Subject: **Bid No. 8148-W4, Norrback School Fire Pump Replacement / WPS**

ADDENDUM NO. 3

Norback Water and
Fire Pump
Replacement

construction plan - first floor

2 demolition plan - first floor
1/2" = 1'-0"

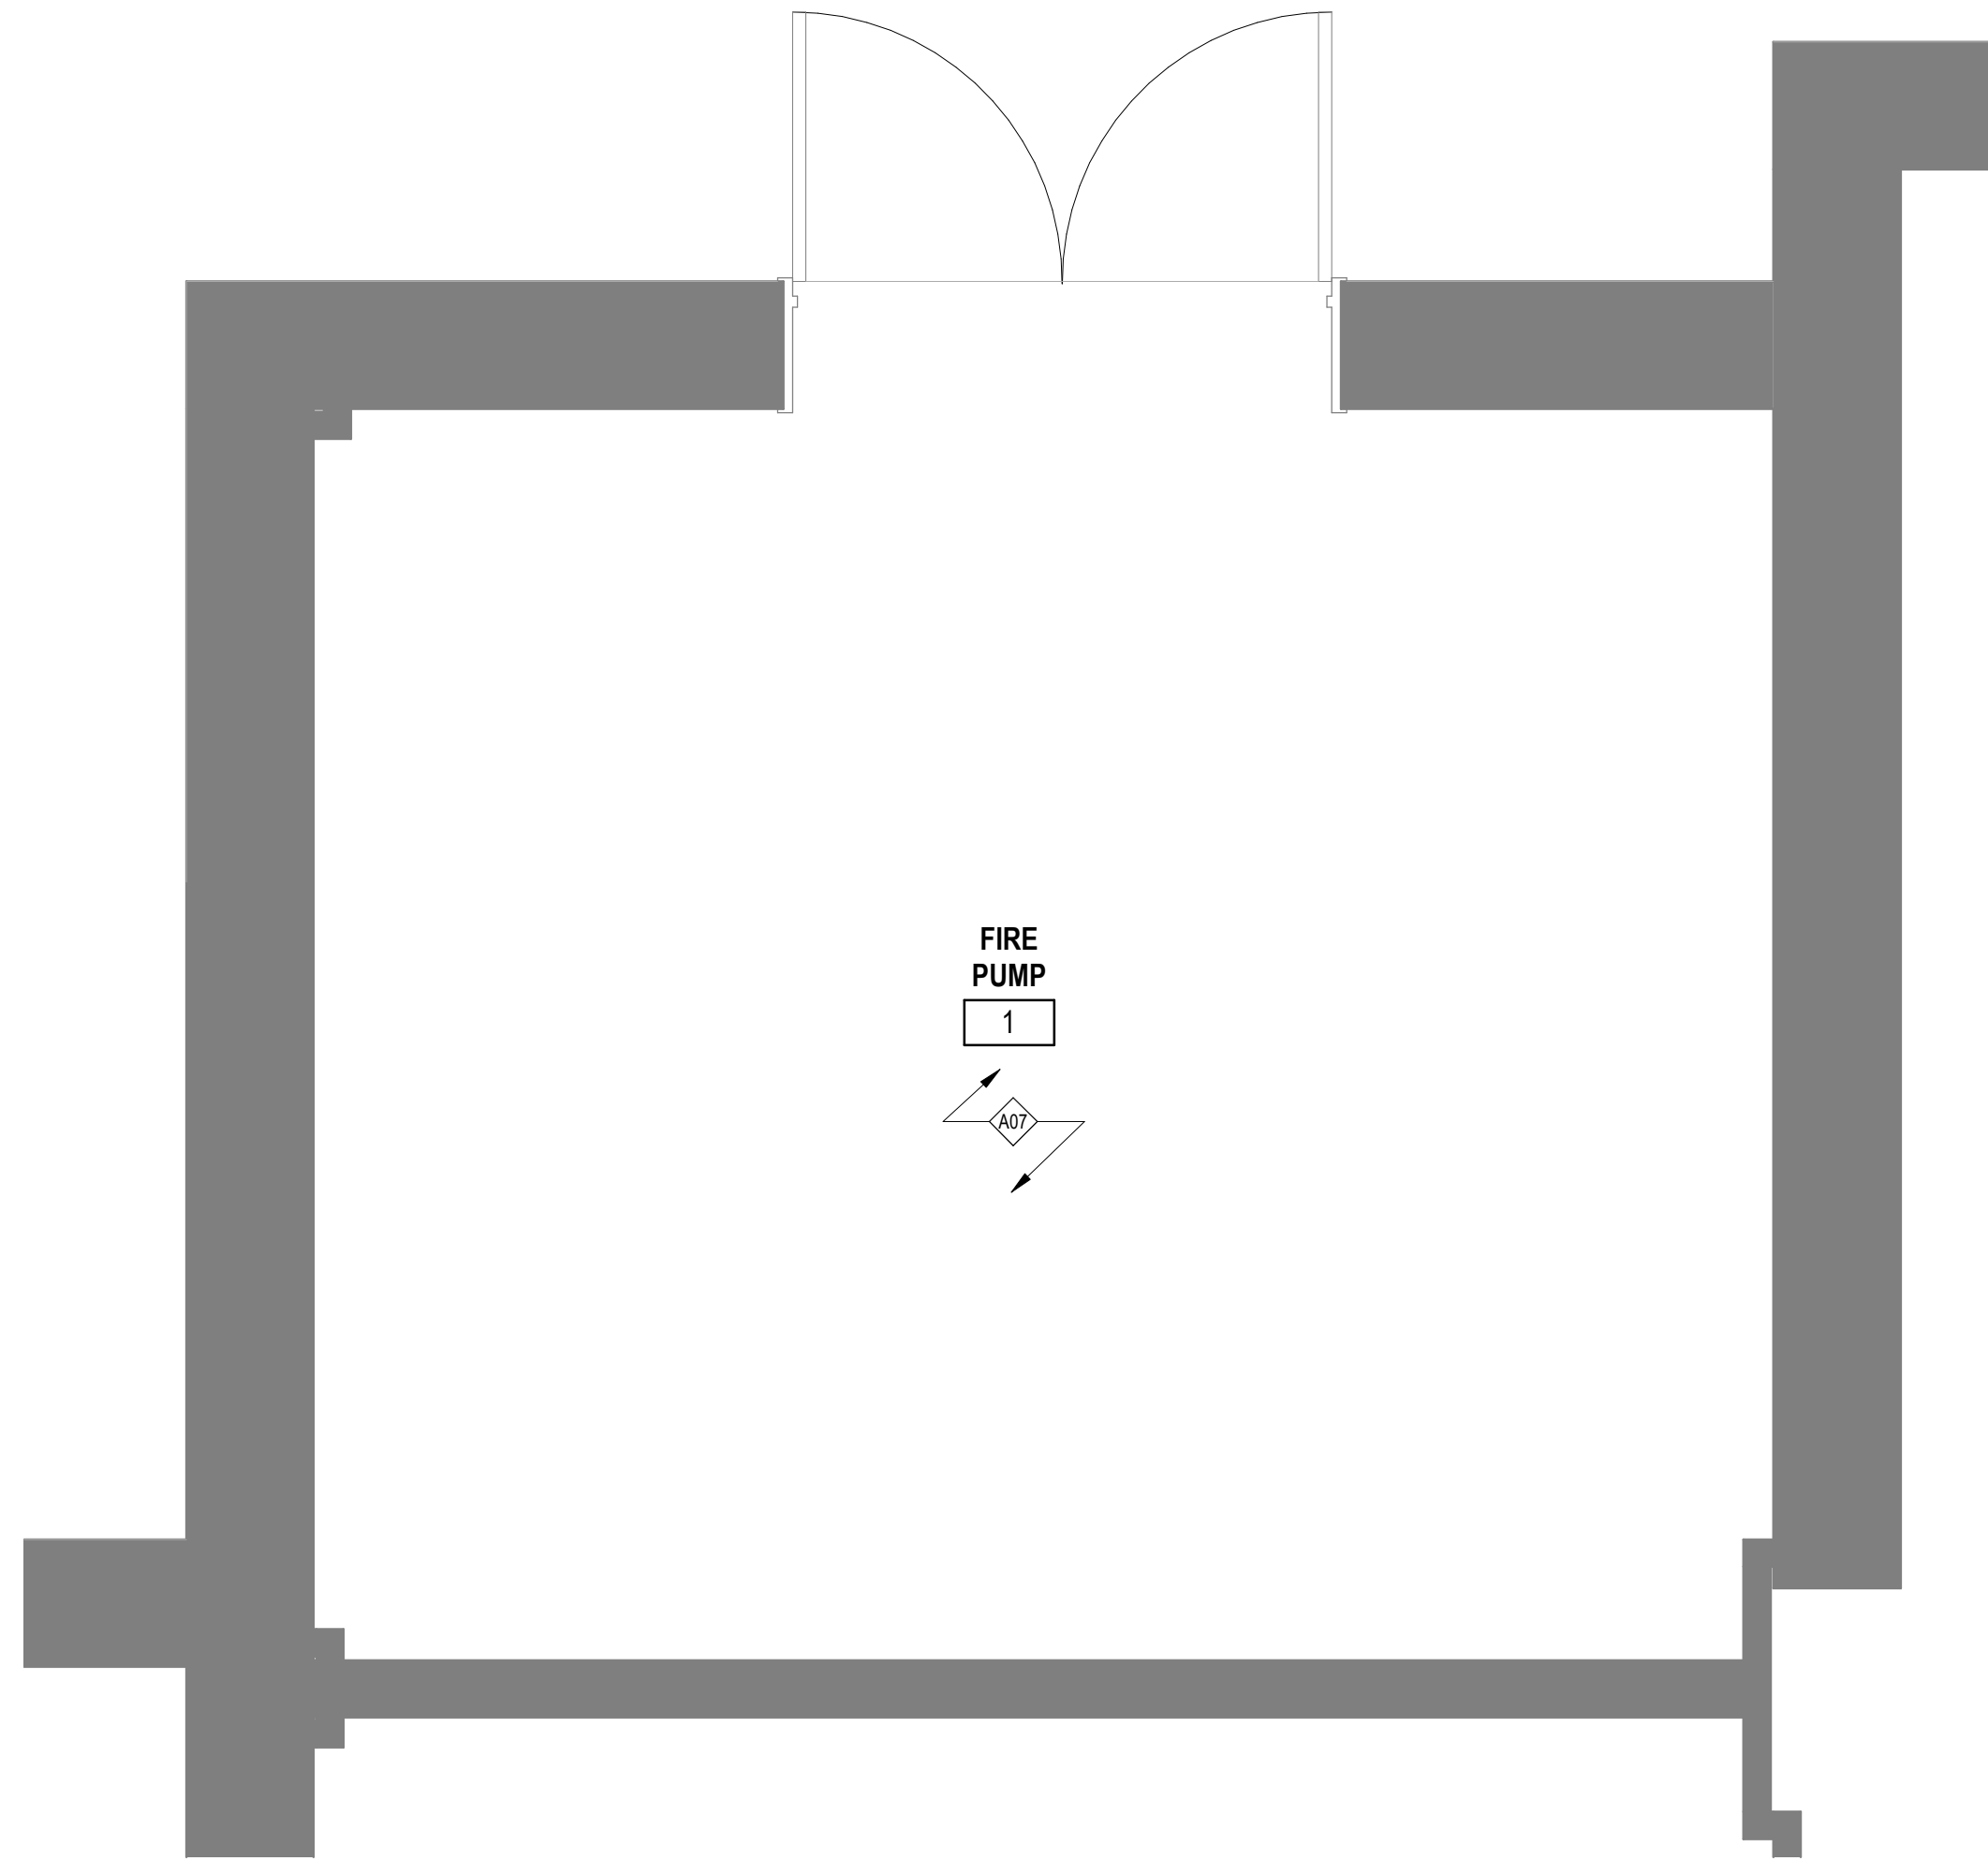
Can it be confirmed that the wall between the fire pump room and the water pump room still needs to be fire rated? (The building code may allow it not to be fire rated as was discussed at the walk thru) **See updated drawings. The wall between the pumps has been removed from the scope of the work.**

- <001> REMOVE WALL IN ITS ENTIRETY. PATCH ADJACANT WALLS, FLOORS AND CEILINGS AS REQUIRED.
<002> REMOVE DOOR AND FRAME IN ITS ENTIRETY.
